**Re: NGI Management Pty Ltd | Objection | State Significant Development SSD 17\_8876**

As the owner of the Edinburgh Castle Hotel, which is adjacent to the sites at 125-129 Bathurst Street, 131-135 Bathurst Street, 296-300 Pitt Street and 302 Pitt Street Sydney, NGI Management Pty Ltd objects to the State Significant Development SSD 17\_8876 (Sydney Metro Pitt Street (South) Over Station Development Concept Development Application (SSD 17\_8876)) for the reasons set out below.

#### **5.1.2.2 Side and rear setbacks**

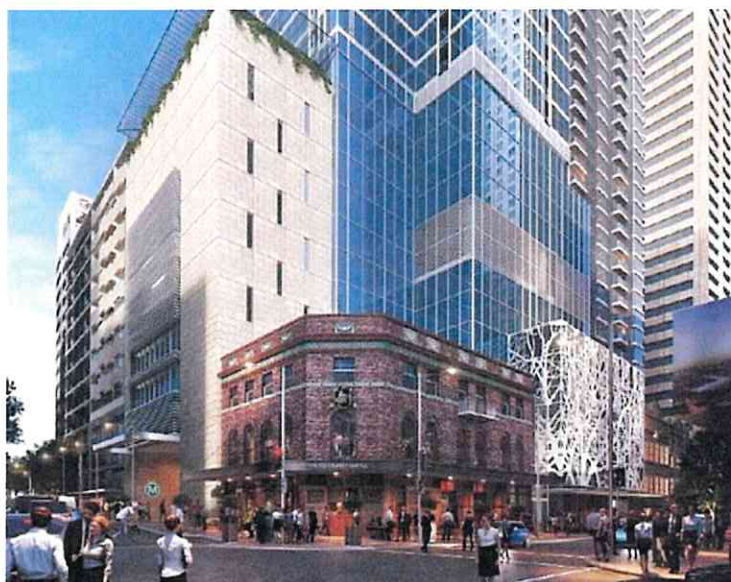
- (1) Buildings must be set back a minimum weighted average of 8m above the required street frontage height. This setback may be reduced in part by up to 2m provided that the weighted average setback from the street frontage alignment is 8m as shown in Figures 5.4 to 5.6. No part of the building is to be setback less than 6m.
3. The proposed tower form includes no setback to the Edinburgh Castle Hotel and fails to comply with required tower setbacks under Sydney Development Control Plan 2012, which requires a setback of 3 metres to 12 metres, depending upon the use of the building.
4. The proposed residential tower envelope includes essential windows to bedrooms and other habitable rooms on the common boundary with the Edinburgh Castle Hotel (nil setback) and fails to comply with required tower setbacks under Section 5.1.2.2 of Sydney Development Control Plan 2012 (as

relevantly extracted below), which requires a setback of 6 metres below 45 metres, and of 12 metres above 45 metres.

- (4) Up to a height of 45m, a minimum setback of 6m is required from the side or rear property boundary for principal windows or balconies for residential buildings, serviced apartments or hotels.
- (5) Above a height of 45m, a setback of 12m is required from the side or rear boundary for residential buildings, serviced apartments or hotels to ensure visual privacy is achieved between dwellings.
